Product change notification

PCN09-3-CCM

Following the development of new constraint and usage related to the smart card connector in its environment we've released a new generation of CCM01-MK2 (V2) to replace completely the existing products (V1)

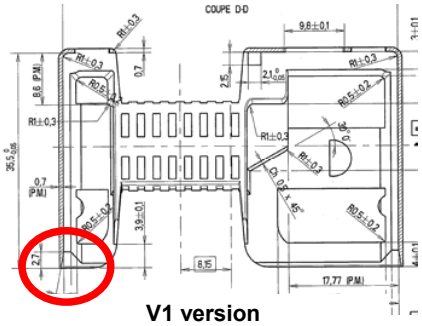
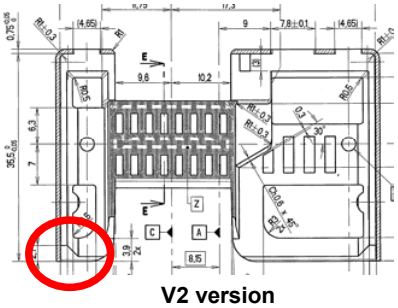
To limit insulator being cut at card entry

We removed the lateral chamfer (card guiding weak point): Thickness increase of the card entry wall

Wall resistance moved up to 75N for card wrongly inserted and to 40N for lateral insertion

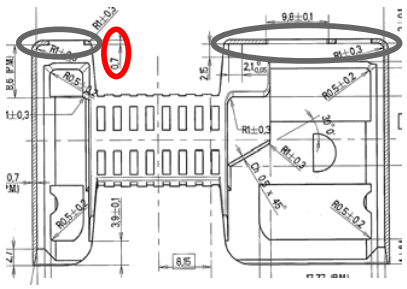
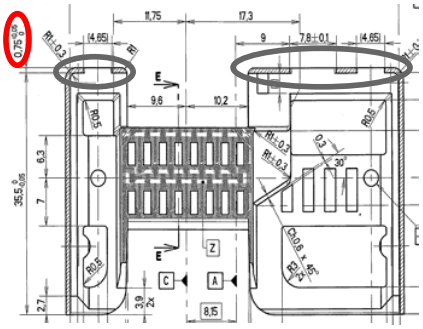
To limit card stop breakage

Card stop section improvement

- plastic wall thickness from 0.70 to 0.75mm
- support surface increase

Card stop resistance moved up 30% at 335N

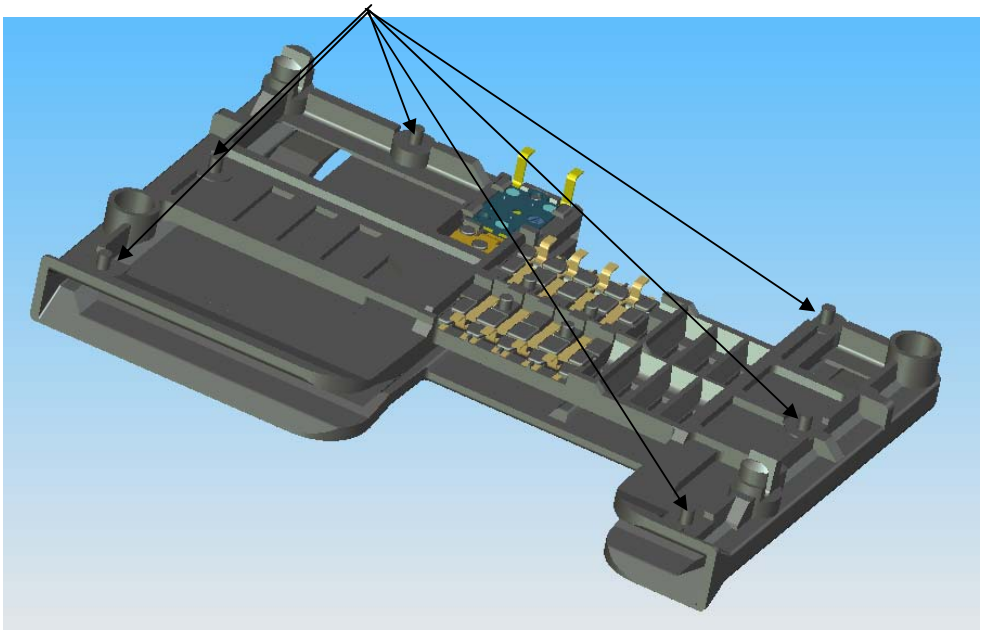
No changes have been brought to this new generation of product in term of form factor, global volume, PCB layout, or available space below the connector for extra components. The only mechanical difference is the appearance of 6 little pegs below the insulator:

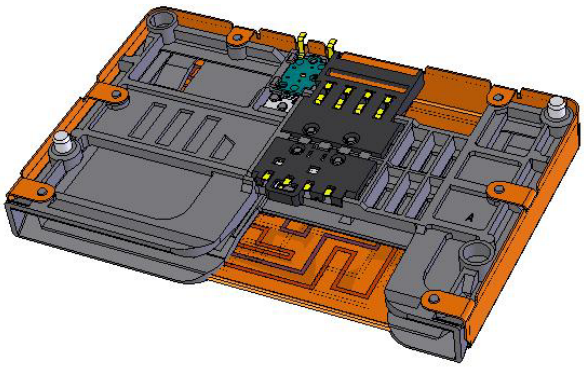
The pegs are necessary for the optional APS cover protection as shown on the figure below:
